# Product Support Bulletin 2015-007

## Maintenance of Way ~ Work Equipment Bulletin

**SUBJECT:** Axel Key Keeper Plate Kit , Nordco P/N 98760360

**MACHINE MODEL(S):** TRIPP Models A,B,C and D

KIT: 98760360  
INSTALLATION

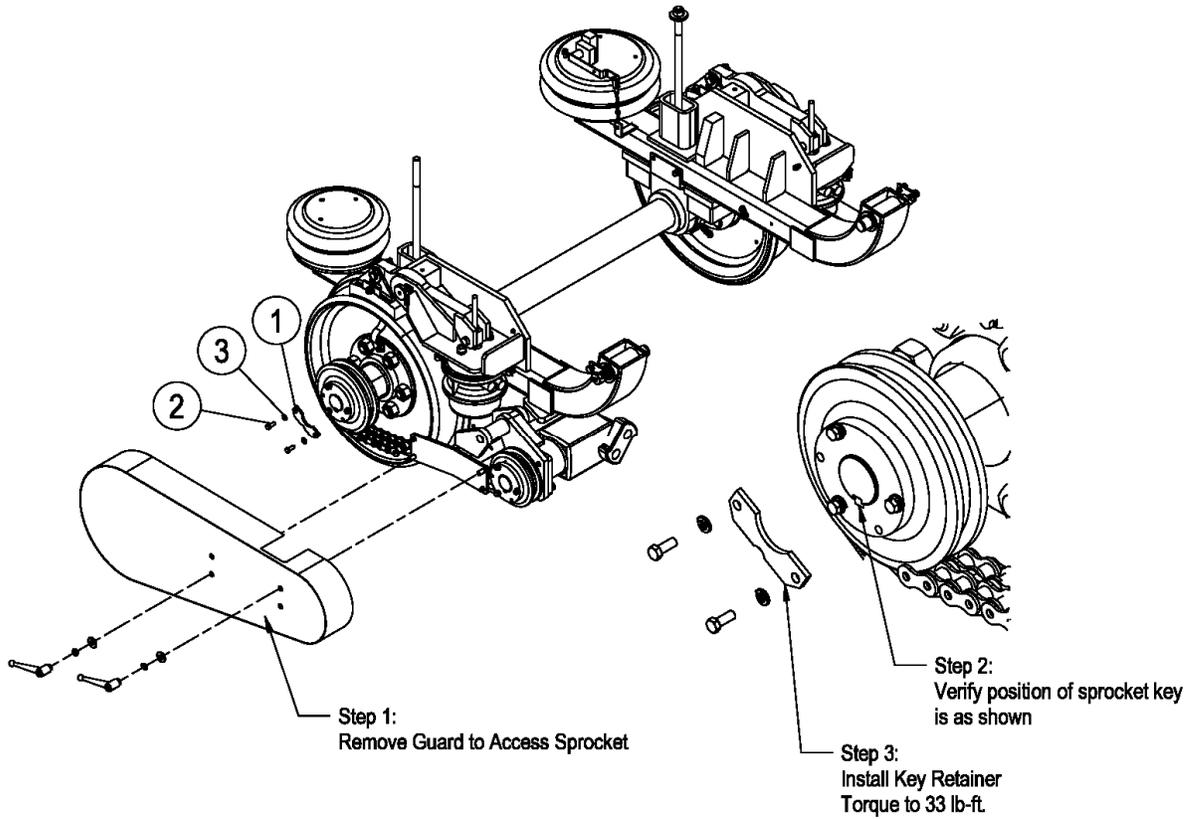
**SUMMARY:** Kit was created to hold sprocket key in place on the Tripp Axles.

**OPERATIONAL IMPACT:** The sprocket keys are more rigidly retained preventing keys from backing out of sprockets.

**ACTION:** The Sprocket key retainer bolts directly to the Sprocket using existing holes, see page 2 for details. Kit includes components to complete one axle, two kits required per machine
